# Aro Valley cycleway audit - safety and accessibility

90% design audit

**Paneke Pōneke**  
Bike network plan

October 2022

Figure 2.6-1: Sharrow too close to parking – 25 Raroa Road

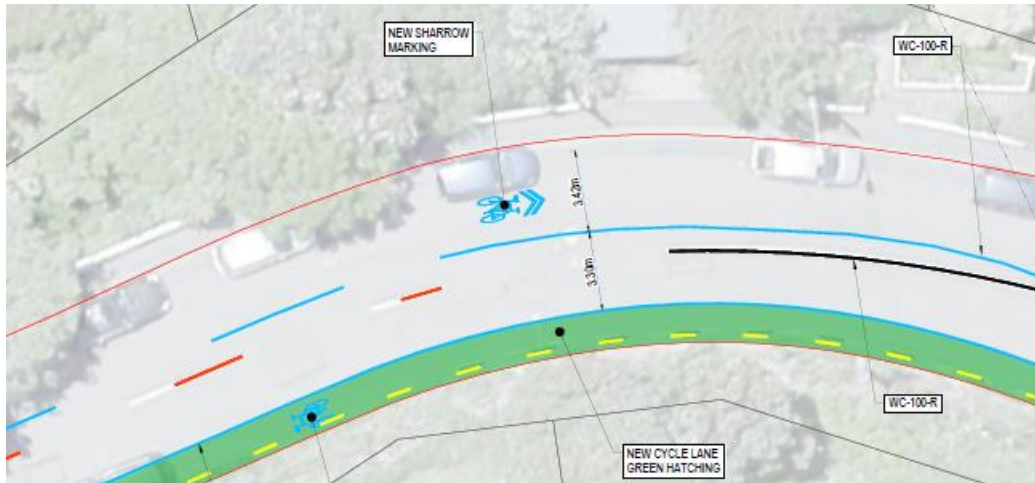
Some sharrows have been marked too close to on-street parking. Locations include:

- 28 Buller Street (opposite side of road)
- Raroa Road north-west of Mount Pleasant Road (but will not need to be changed if no-stopping is introduced as per issue 3.6.)
- 147 Raroa Road
- 57-119 Raroa Road
- 25 Raroa Road (see Figure 2.6-1)
- 7 Raroa Road (just south of)
- 21 Raroa Crescent (opposite side of road); although this site may have low to no parking demand and therefore the positioning may be acceptable
- Northland Tunnel Road to Chaytor Street (both sides of road)

This may encourage cyclists to ride in the “door zone” of parked vehicles. If a driver opens their door and a cyclist collides with it, they will likely fall into the path of traffic, which would be very likely to result in serious injury due to the vehicle speeds involved and the vulnerability of cyclists lying on the ground. Given the parking demand along the route, such incidents are expected to be common.

2.6.1	Where on-street parking is provided / permitted and parking demand is high, mark sharrows closer to the centreline, to discourage cyclists from tracking in the door zone of parked cars.
-------	---

<b>Designer</b>	Agree, design to be updated.
<b>Safety Engineer</b>	Agree with CAT and Designer.
<b>Client</b>	Agree.
<b>Action</b>	Sharrows to be moved closer to the centre line where passing parked cars.

**Figure 3.2-1: Speed cushions near bus stop, east of Holloway Road**

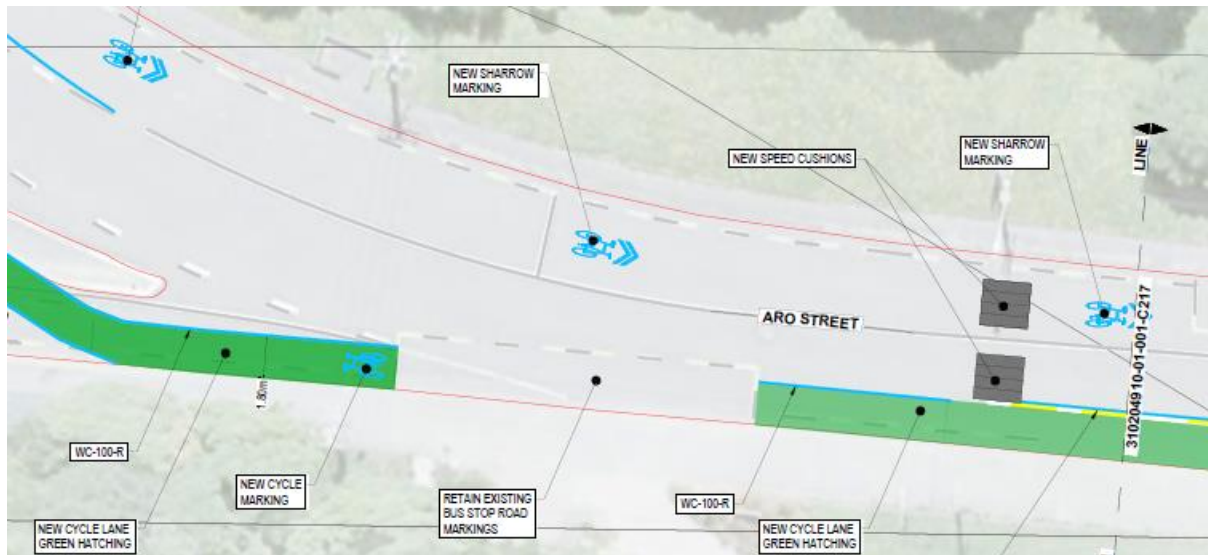
If there is a bus parked in the Karori-bound bus stop on the approach to Holloway Road (see Figure 3.2-1) approaching cyclists will have to wait until passing the speed cushion before entering the general traffic lane to pass the bus. This is a reasonably tight manoeuvre and will be complicated by available gaps in the motor traffic, plus uphill riding.

This is not a high frequency bus route, so it is expected that crashes occurring due the geometry in this location will be infrequent. But the vulnerability of cyclists and speed of motor vehicles means that it is likely to result in serious injury. Therefore, this is a moderate issue.

3.2.1	Relocate the proposed speed cushions just west of Holloway Road. Consider placing them westwards, a bit past the bus stop so that cyclists passing a bus have a chance to re-enter the cycle lane before encountering a speed cushion.
-------	--

<b>Designer</b>	Cushions removed in this location.
<b>Safety Engineer</b>	Agree with Designer. However, speeds should be monitored, and alternate speed mitigation installed if necessary.
<b>Client</b>	Agree with Safety Engineer

**Action** | Remove speed cushions and monitor. Add speed mitigation if necessary.

**Figure 3.5-1: Off-road cycleway transitions to mixed traffic on Raroa Road**

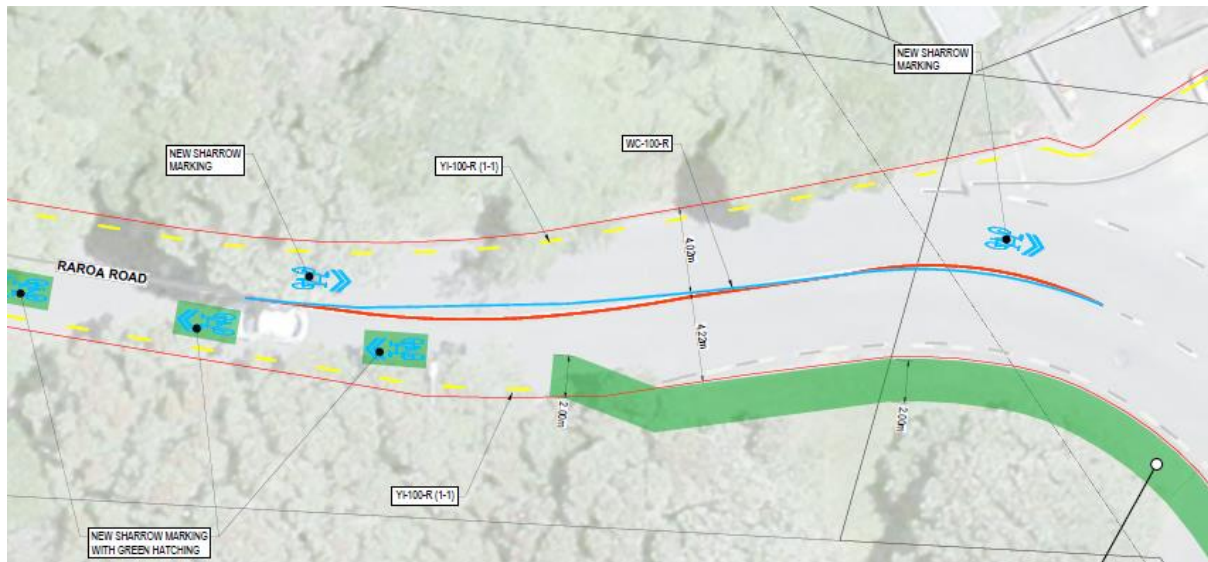
The 30% CASA identified an issue with the transition of the Karori-bound off-road cycle path to mixed traffic on Raroa Road, which involved safe-hit posts that appeared to result in a traffic lane narrower than the legal minimum width of 2.5 m. The 90% design (see Figure 3.5-1) has removed the flexiposts but still appears to have a short section of on-road cycle lane which would result in a section of the general traffic lane being approximately 2.3 m wide.

Furthermore, without the safe-hit posts, the cycle lane creates an unacceptable taper on the general traffic lane.

<b>Designer</b>	Path as been extended to the west, and now feeds cyclists into the trial 750 mm “cycle shoulder”.
<b>CAT</b>	
<b>Safety Engineer</b>	Agree with Designer. To be included in monitoring plan, and modified if necessary.
<b>Client</b>	Agree.
<b>Action</b>	Extend path and merge into ‘cycle shoulder’

**Figure 3.6-1: Narrow sections of Raroa Road in city-bound direction**

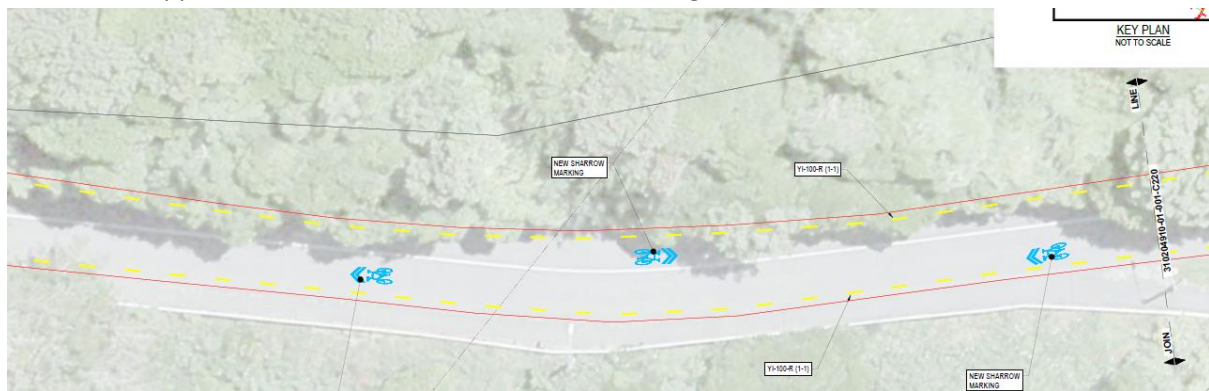
There is a section of Raroa Road east of Entrance Street (sheet 21 of the 90% plans) where the city-bound lane appears to be narrower than the minimum legal lane width of 2.5 m.

This is located in a hilly, winding section of road where people cycle in mixed traffic. Having a lane that is too narrow, in combination with these other factors, could result in conflict between cyclists and motor vehicles in either direction.<sup>1</sup>

**Figure 3.7-1: No-stopping in the vicinity of 166 Raroa Road**

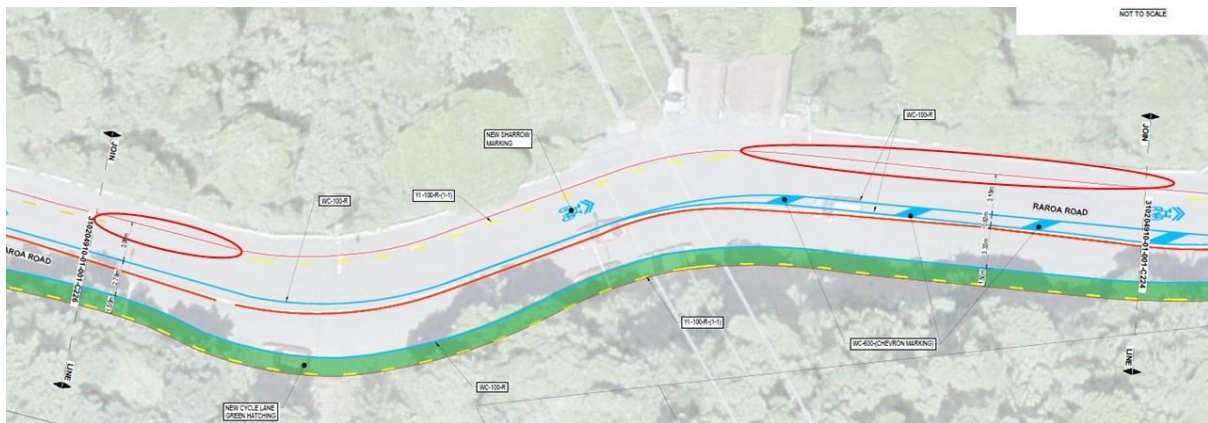
Raroa Road forms a hairpin bend at Mount Pleasant Road and has a steep gradient. Near 166 Raroa Road, some no-stopping restrictions have been added to accommodate the new cycle lane and flush median. However, the CAT suggests that it would be preferable to also add no-stopping in the sections circled in red in Figure 3.7-1, to provide a consistent stretch of route.

If vehicles are parked in the sections circled in red in Figure 3.7-1, the available lane width will be too narrow for moving vehicles to stay in their lane while passing the parked vehicle. Drivers may be too overloaded thinking about avoiding hitting the parked car, watching for oncoming traffic, negotiating the gradient and bends etc to also remember to look out for cyclists travelling in the mixed traffic lane.

3.7.1	Continue the broken yellow no-stopping lines in the sections circled in red in Figure 3.7-1 in the vicinity of 166 Raroa Road.
-------	--

Figure 3.8-1: Cycleway across Mount Pleasant Road, approaching in-lane bus stop

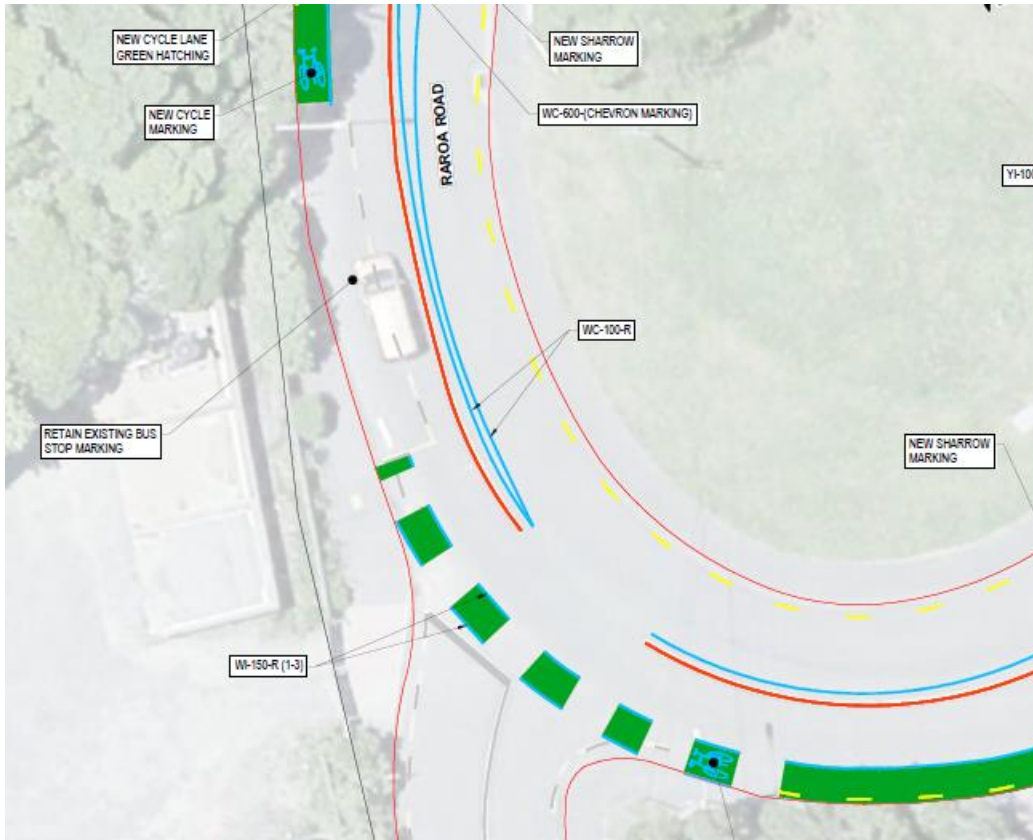
There is an in-lane bus stop in the Karori-bound cycle lane soon after it crosses Mount Pleasant Road – see Figure 3.8-1.

The proposed design extends the green blocks for side street crossings past the side street, resulting in a small block prior to the bus stop. It would be preferable to have a longer section of cycle lane with solid colour prior to the bus stop, to distinguish the bus stop from the side road, particularly for cyclists and motorists turning left out of Mount Pleasant Road.

**Figure 3.9-1: Marked parking spaces adjacent to cycle lane**

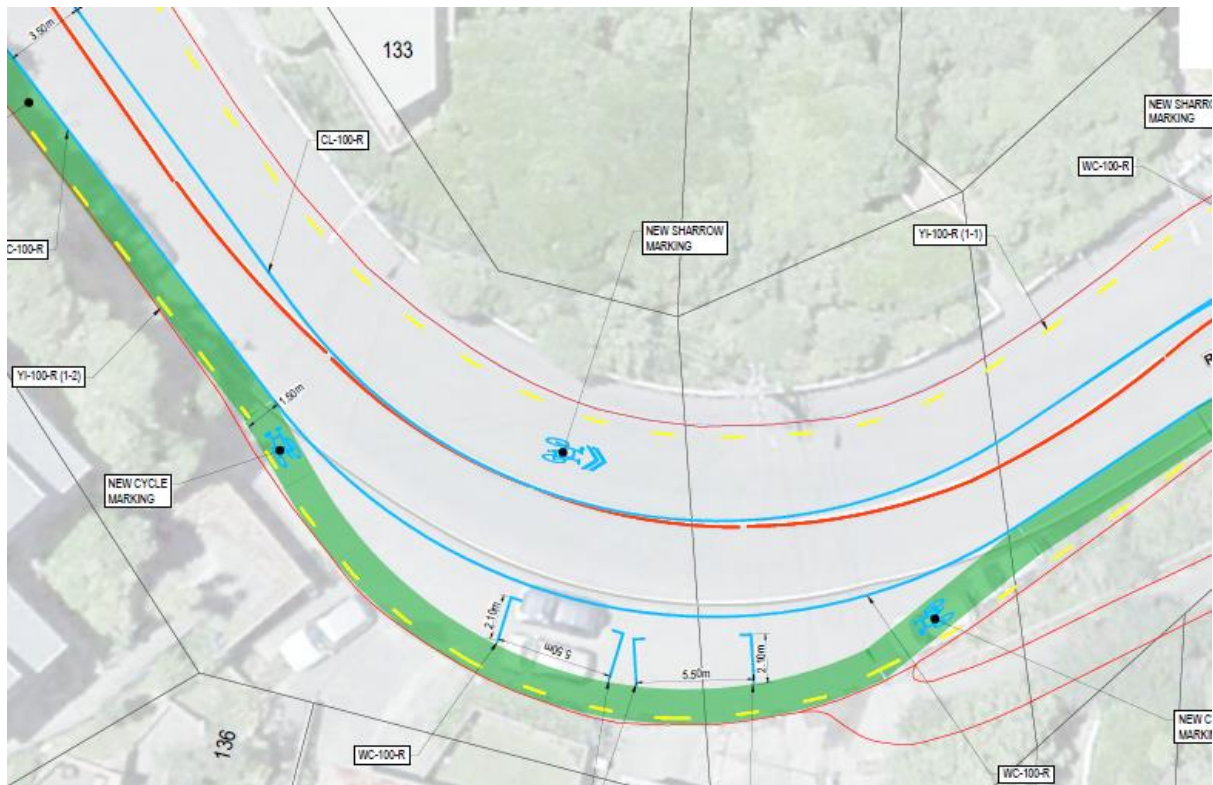
The design shows two marked parking spaces adjacent to the Karori-bound cycle lane in a bend on Raroa Road – as shown in Figure 3.9-1:

There is no physical measure to stop cars encroaching on the cycle lane here. The aerial photos show two cars parked side-by-side – this suggests a high parking demand which may make it likely drivers will park a little over the cycle lane. It also shows that drivers are not concerned about parking close to the general traffic lane, and therefore it could be acceptable to move the proposed parking spaces slightly away from the cycle lane to accommodate a physical barrier, which will also help prevent passenger dooring incidents.

There is also the question about the legality of providing a marked parking space to the right of a broken yellow (no-stopping) line).

3.9.1	Provide a physical barrier (e.g., wheel stops) between the cycle lane and marked parking spaces – move the parking spaces slightly to accommodate this.
3.9.2	Do not mark broken yellow lines adjacent to the car parking spaces.

**Figure 3.10-1: Plunket Street roundabout**

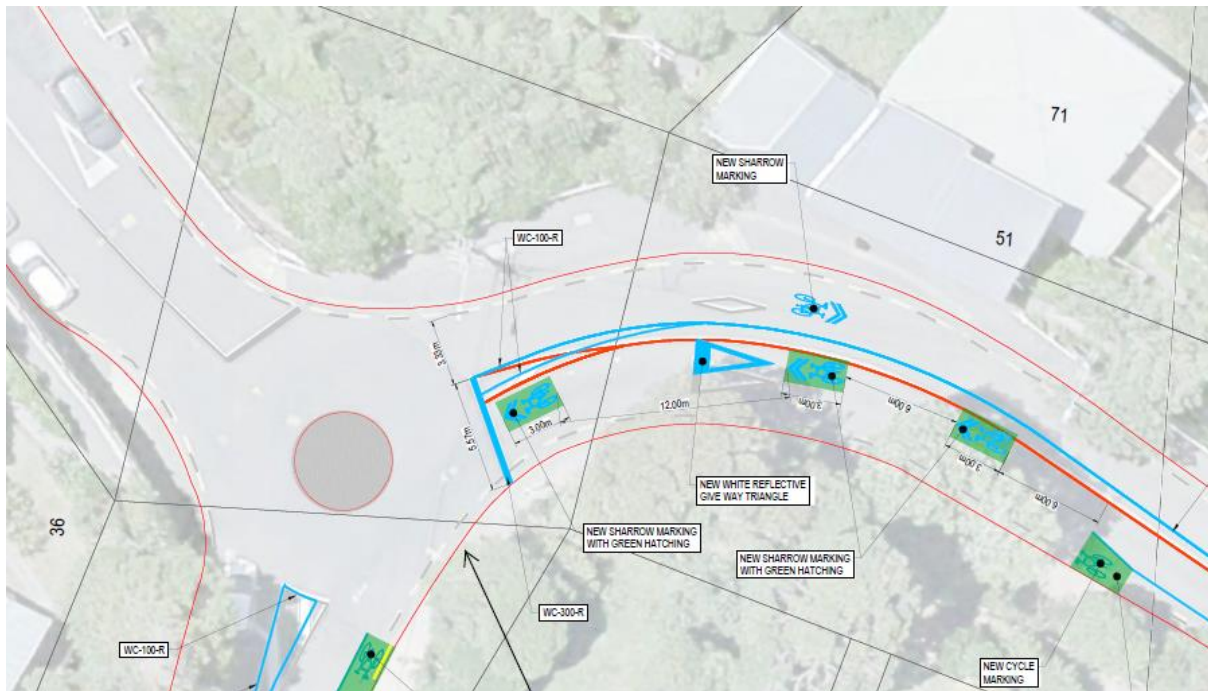
As per the 30% CASA (issue 3.16) the Karori-bound approach to the Plunket Street roundabout has been modified to transition to mixed traffic rather than have a kerbside cycle lane up to the limit line – see Figure 3.10-1.

However, there are some concerns with the way this has been implemented. Firstly, the sharrows are too close to the centreline – they should be positioned in the centre of the lane.

3.10.1	Position sharrows centrally in approach lane.
3.10.2	Add flush median to reduce Karori-bound approach lane width, to minimise the chance of two queues forming.
